CIVIL DRAWINGS
CENTACARE - DEVELOPMENT
1 HAYFIELD PLACE
BRIDGEWATER

MEMO ☐**RFI RESPONSE** ☒**SHOP DRAWING APPROVAL** ☐**PROJECT:** Centacare - Development: 1 Hayfield Place, Bridgewater**SUBJECT:** Response to Brighton Council RFI (DA 2024 / 00035)**RELEVANT DOCUMENTS:**

Aldanmark Engineers have provided the following responses in regard to the Brighton Council's Planning RFI:

SHEET: ROAD AND STORMWATER PLAN - SHEET 2	SCALE: 1:100	TOTAL SHEETS: 42	SIZE: A1
PROJECT No: 23 E 99-113	SHEET: C105	REV: F

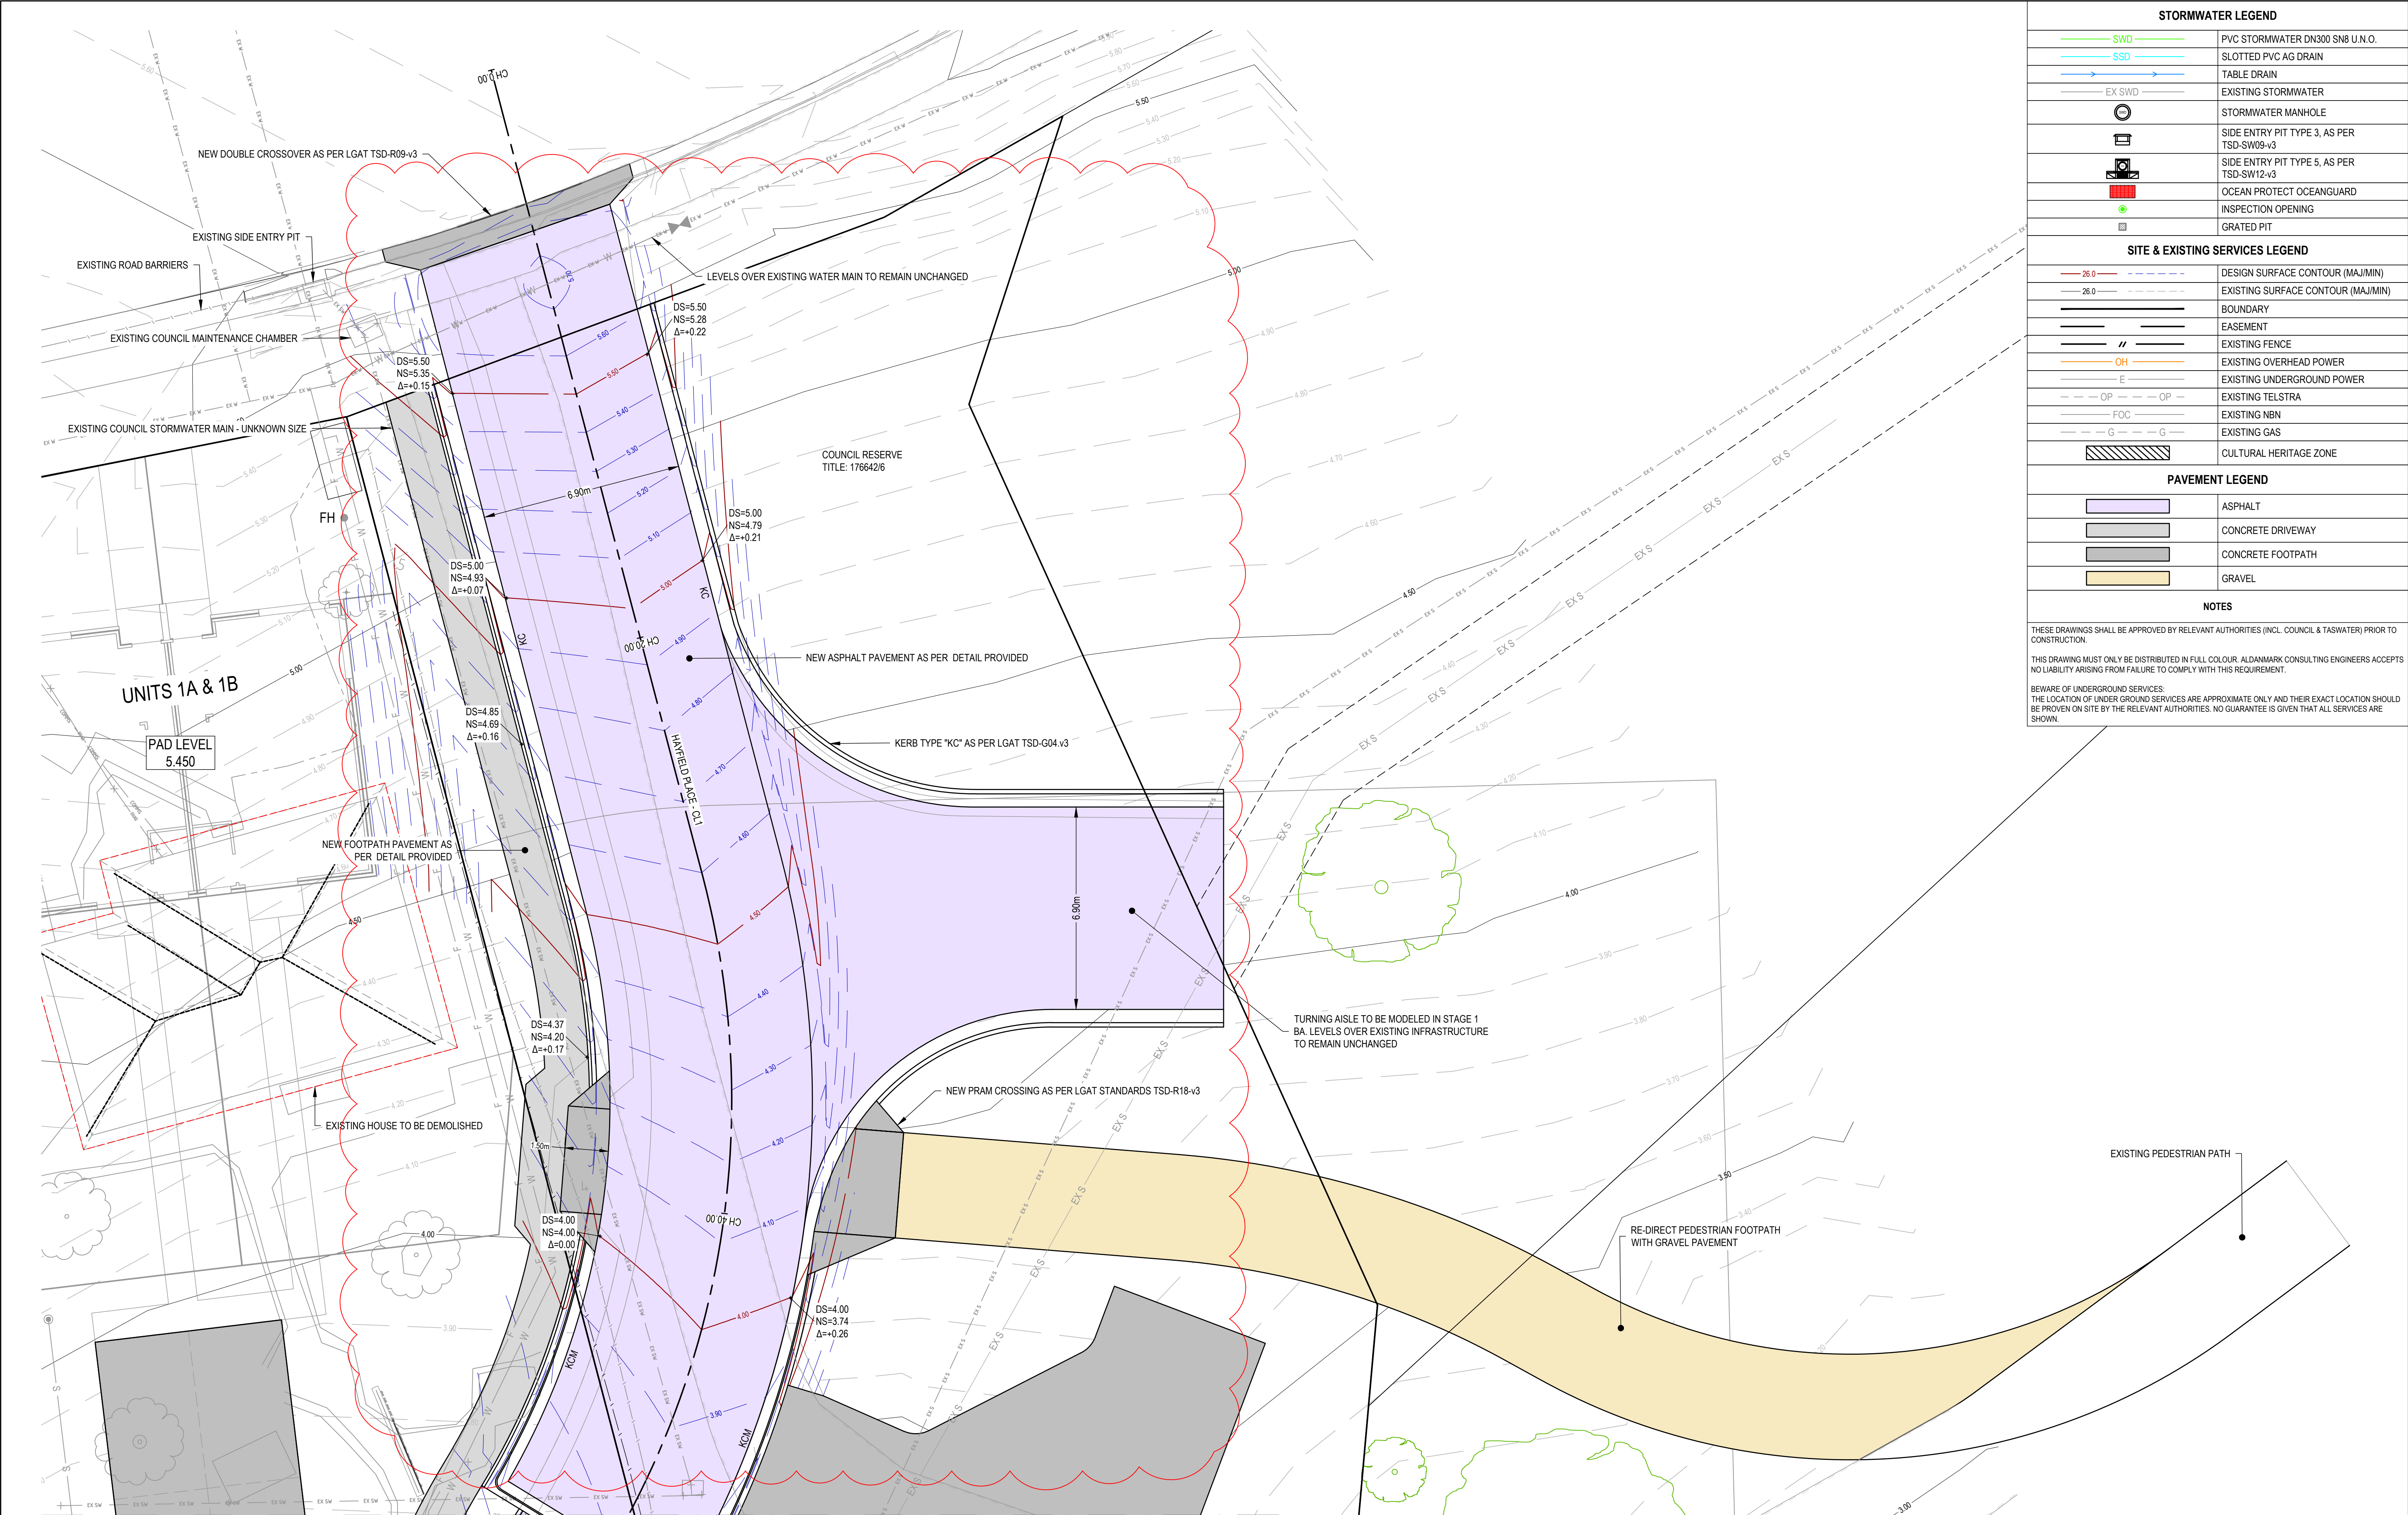
- **b):** The threshold treatment to delineate between the public and private road has been amended and is now shown as mountable kerb (KCM) – see drawing C105.

SHEET: TURNPATH PLAN - SHEET 1

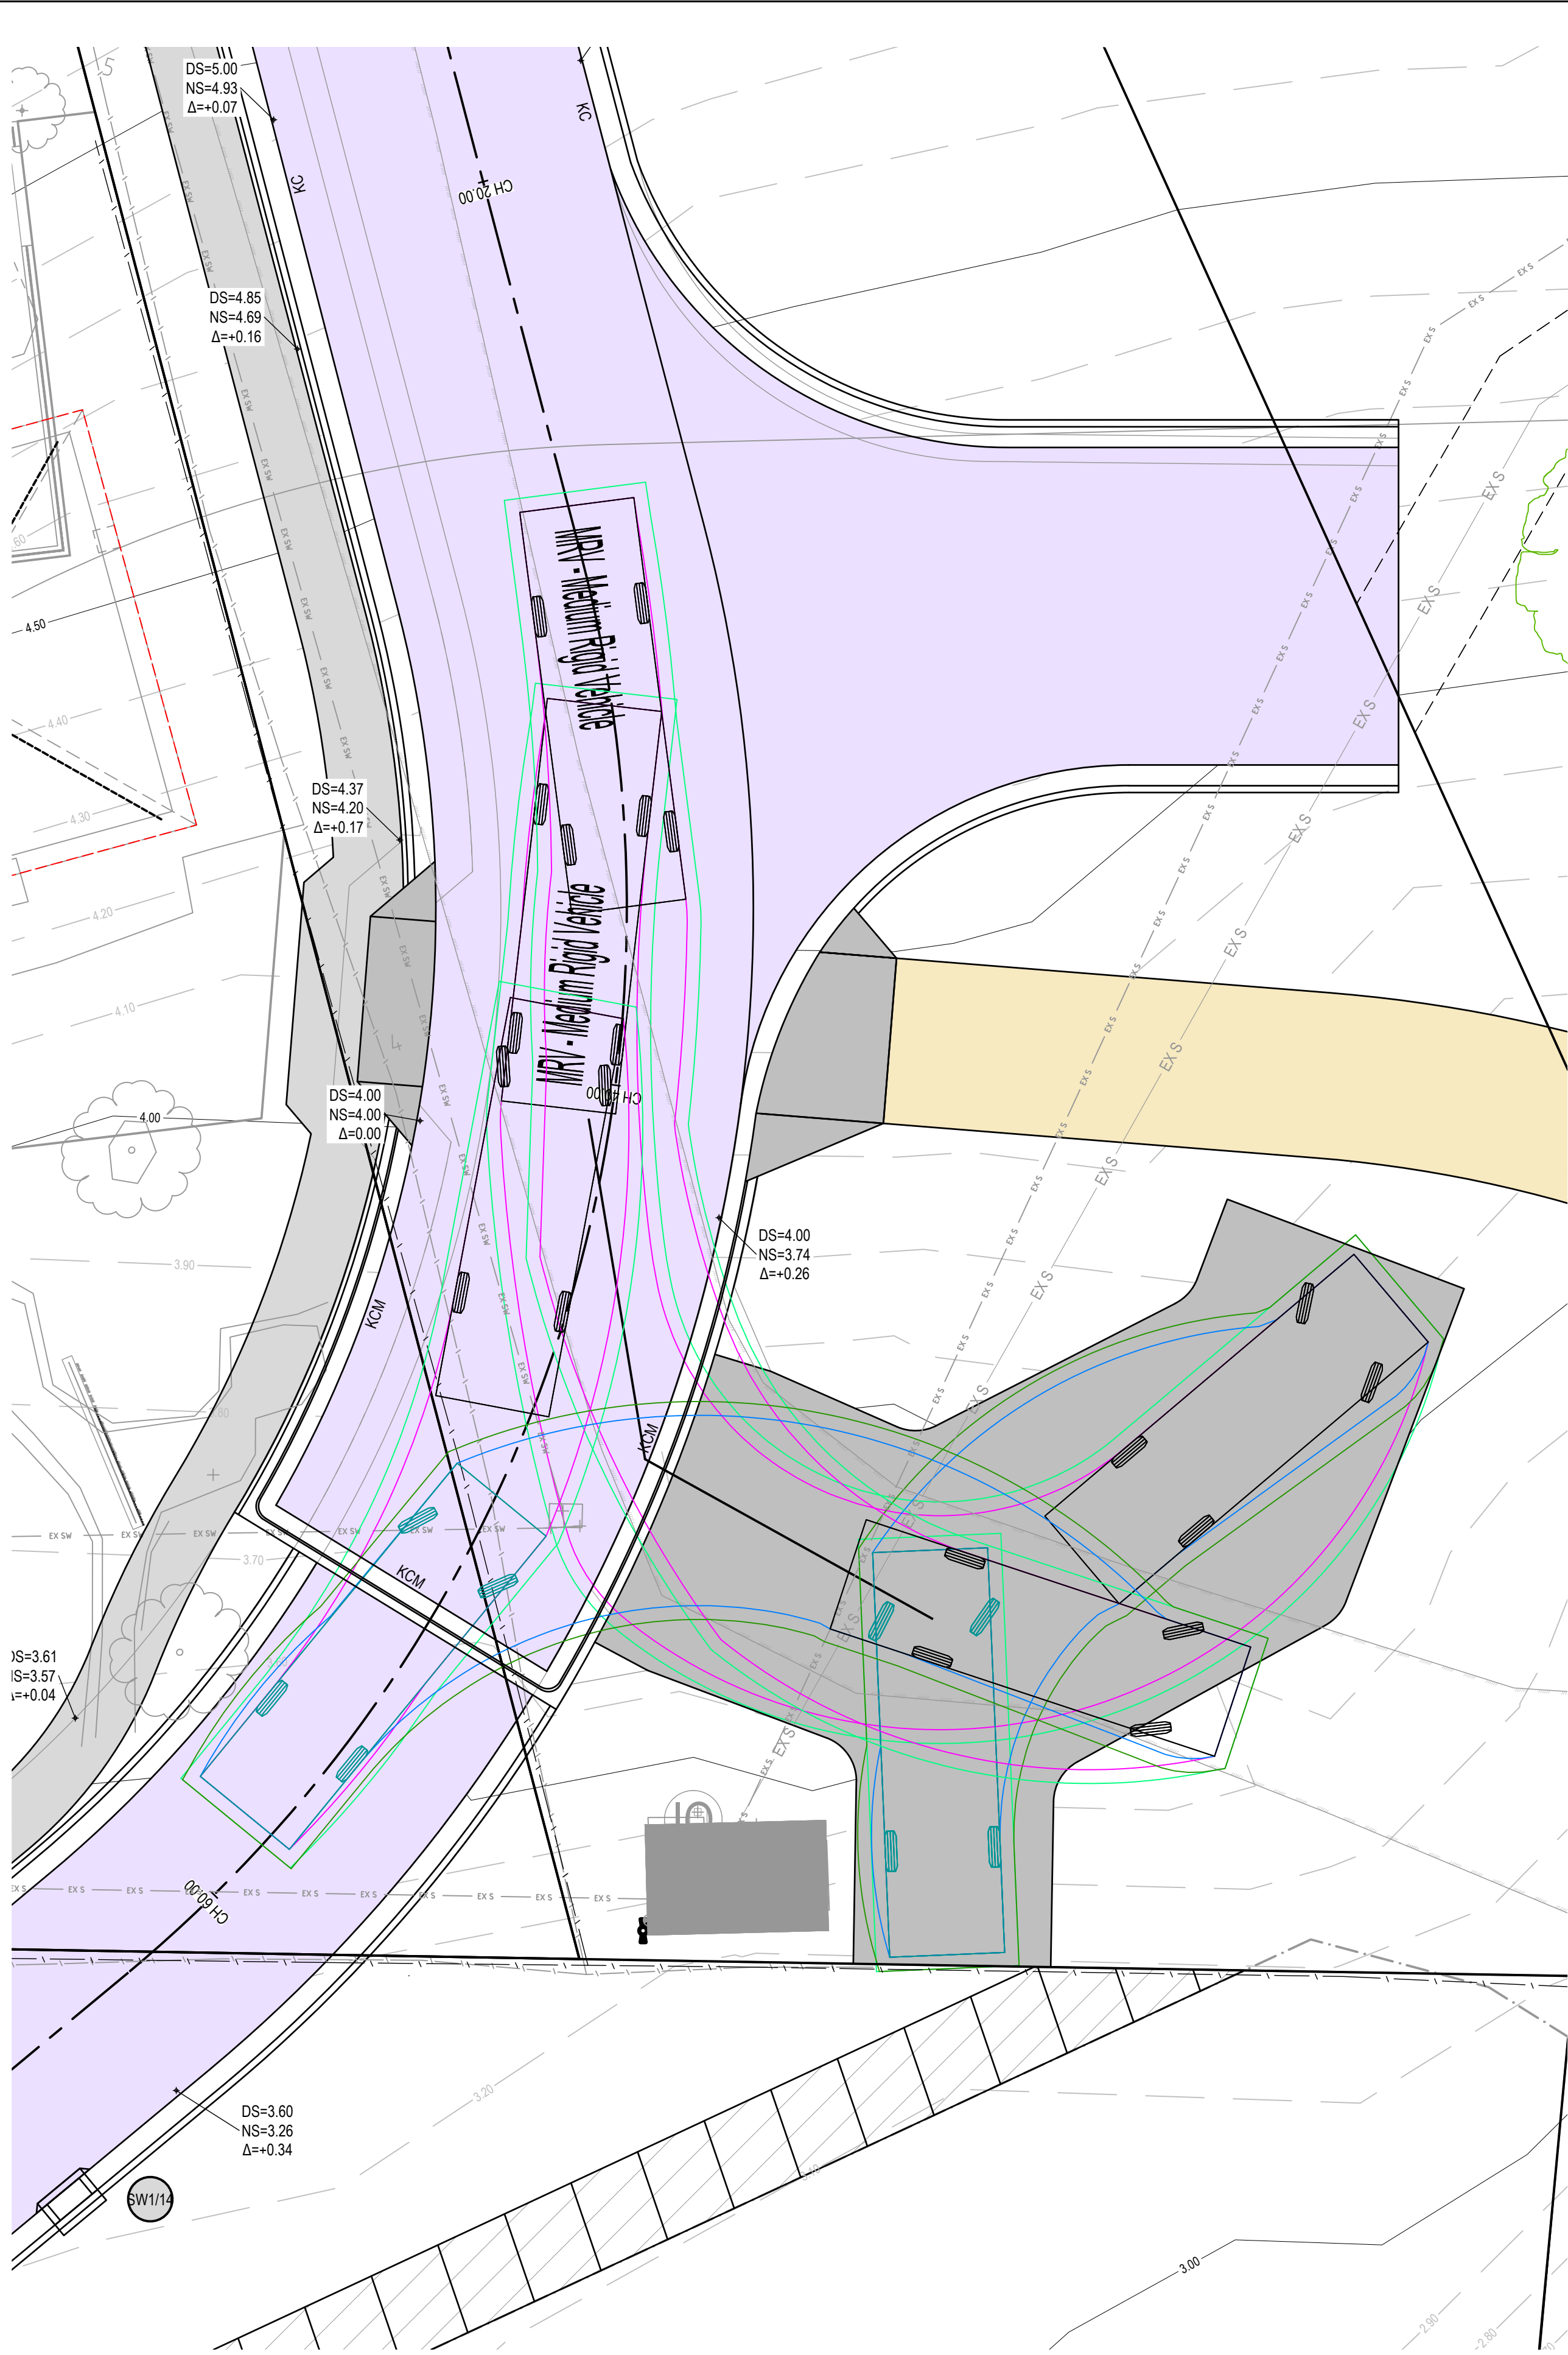
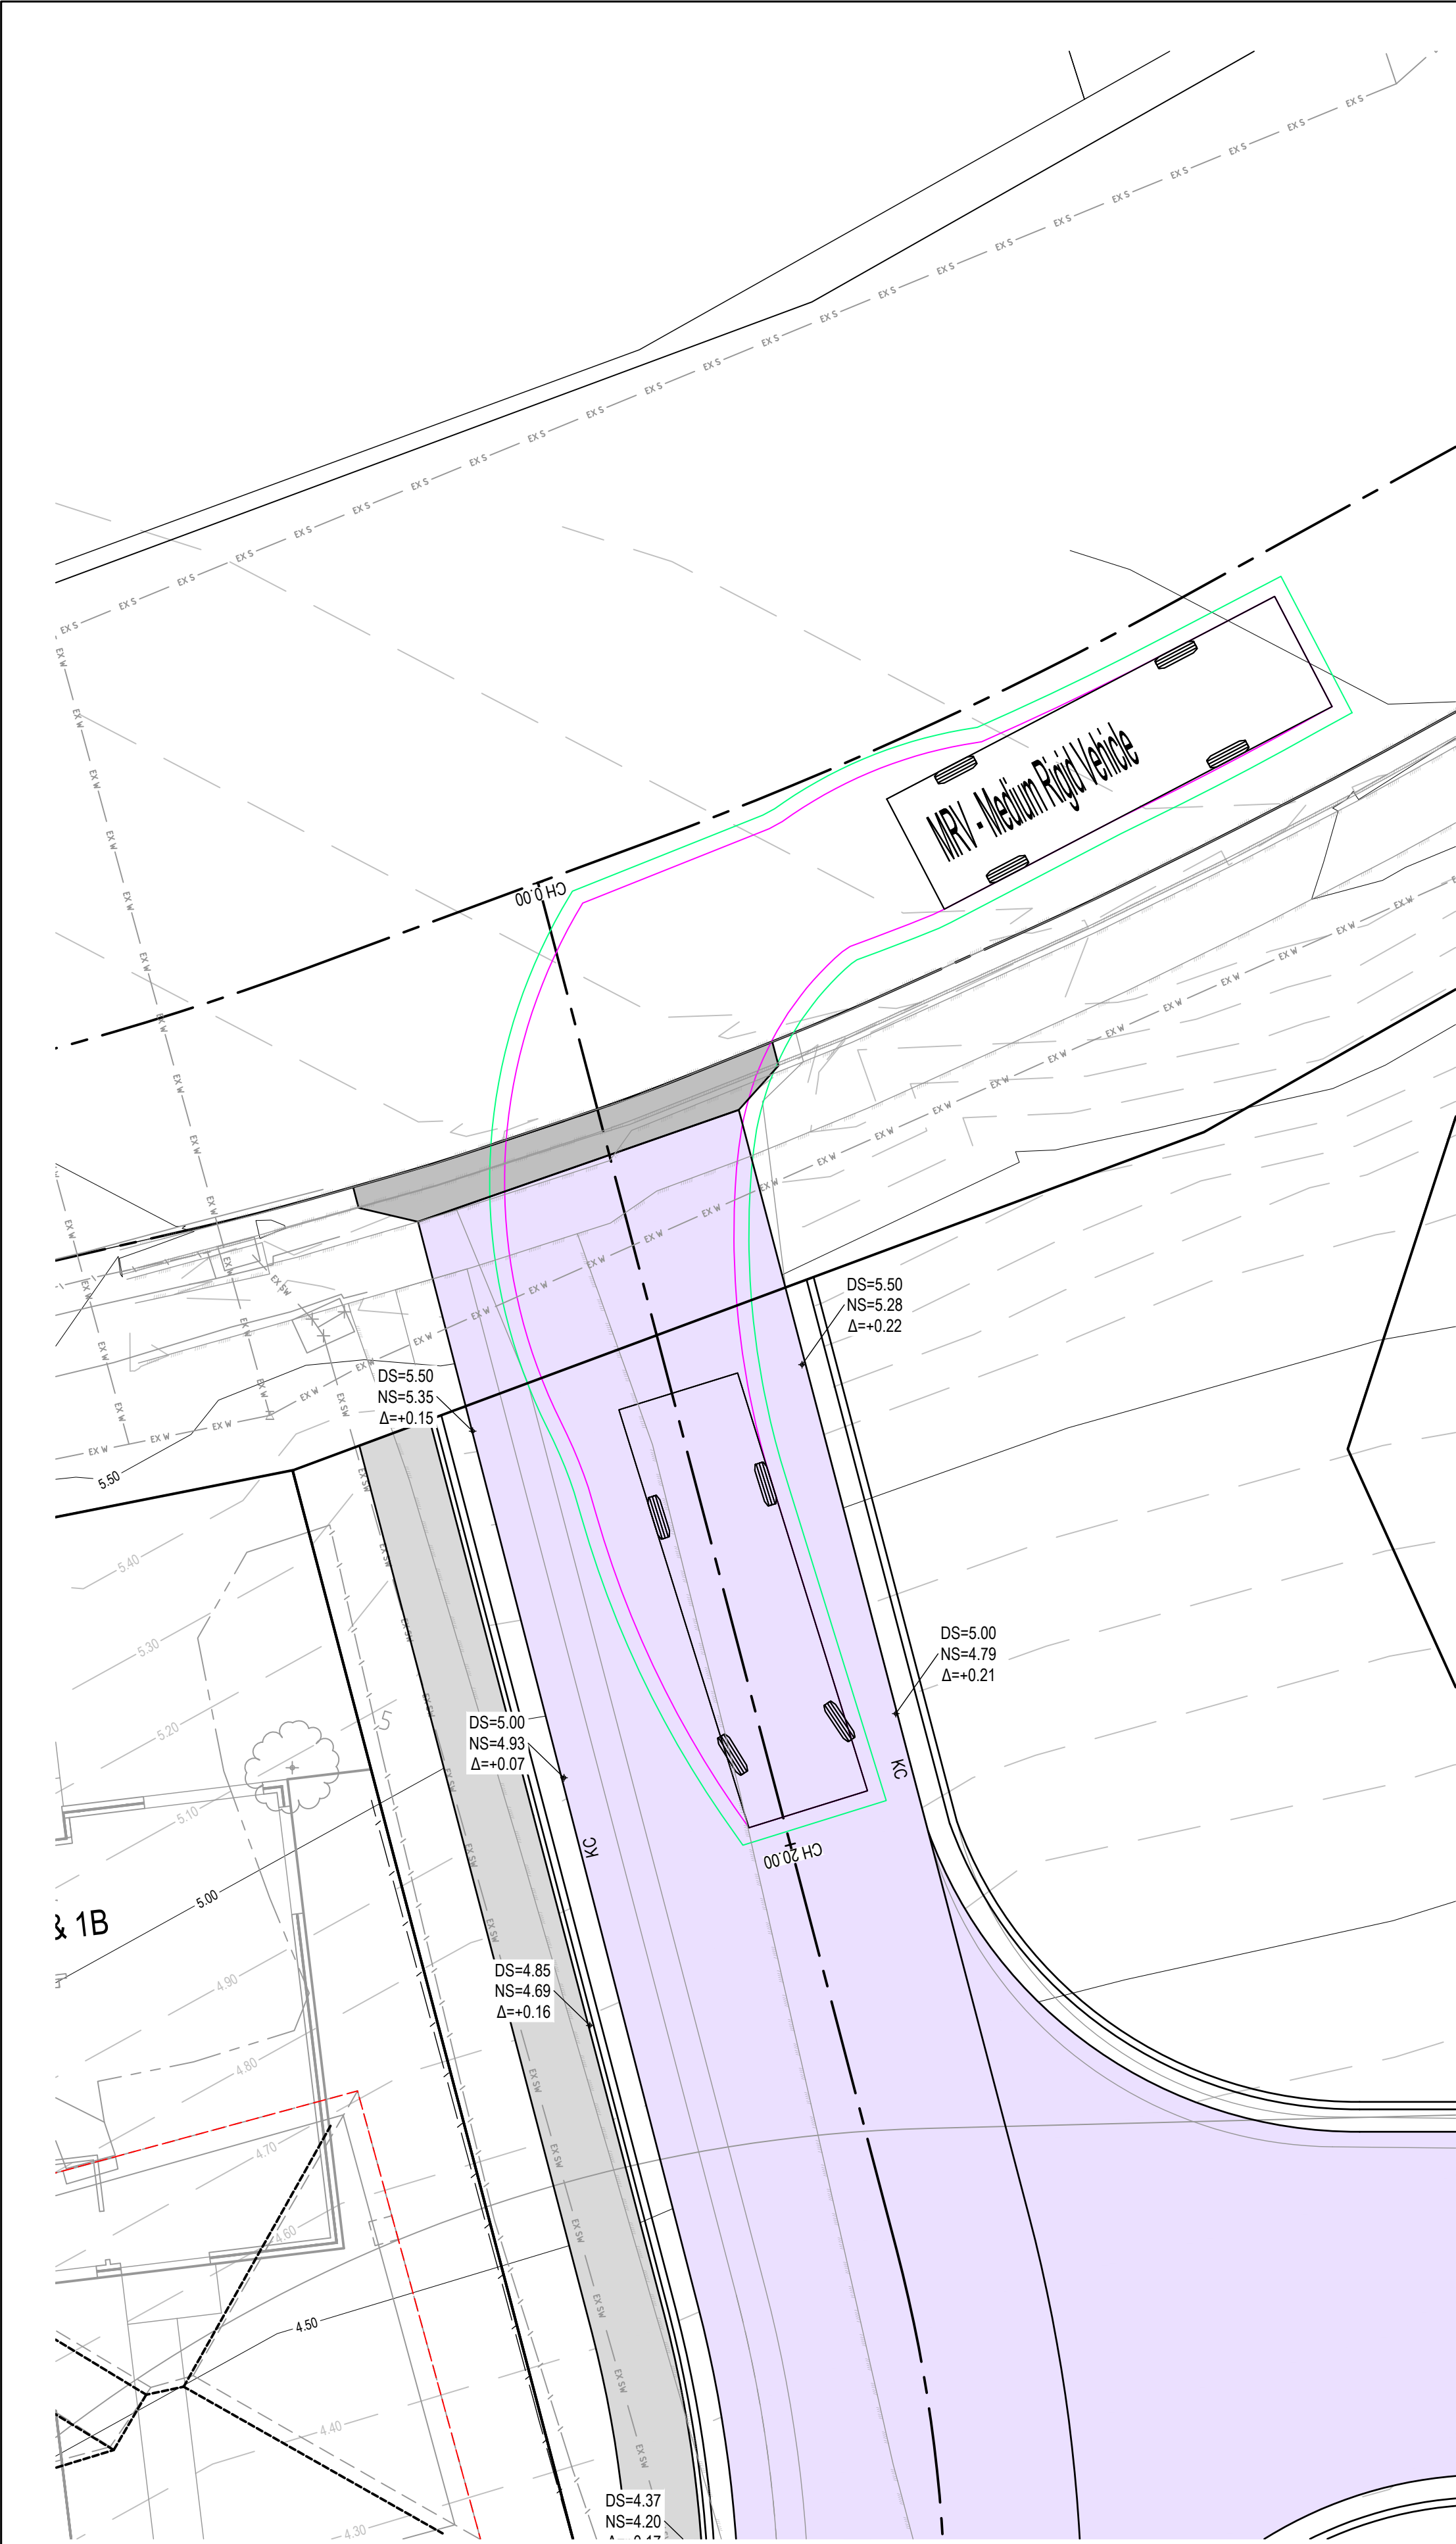
- **Waste Storage and Collection:**
 - **a):** A turnpath using a medium rigid vehicle (MRV) has been provided on drawing C128 to show the turning circle for a rubbish truck. The kerb and footpath have been modified to allow for trafficable use.
